STATE OF MINNESOTA
BEFORE THE
MINNESOTA PUBLIC UTILITIES COMMISSION

**In the Matter of the Distribution
System Planning for Xcel Energy**

Docket No. E002/CI-18- 251

Initial Comments of Fresh Energy

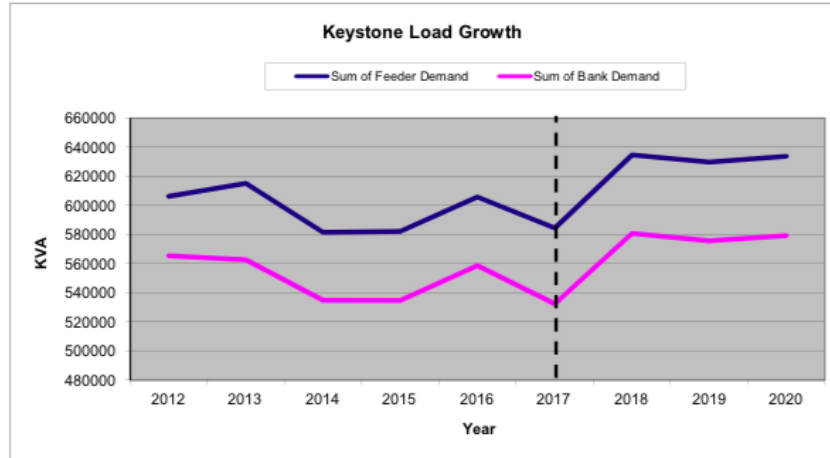
The load forecasts in Figure 67 and in Attachment G of the IDP all reflect a similar, questionable pattern – flat to declining load growth prior to 2017, followed by an unexplained jump in demand in 2018. The load forecast for the Keystone area is particularly egregious and shown below to highlight Fresh Energy's concern.

- What is the rationale for the projected jump in demand from 2017 to 2018 in the Company’s load forecasts? How do the actual 2018 peak demands compare with those depicted in Figure 67 and Attachment G?
- What actions is the Company taking in 2019 to develop more realistic load forecasts?
- The Company explains how multiple FLISR devices across each feeder will provide more granular load measurements.³⁸ How does the Company intend to use this information to improve its feeder- and substation-level load forecasts?
- How does the Company intend to use information from AMI to improve its feeder- and substation-level load forecasts?
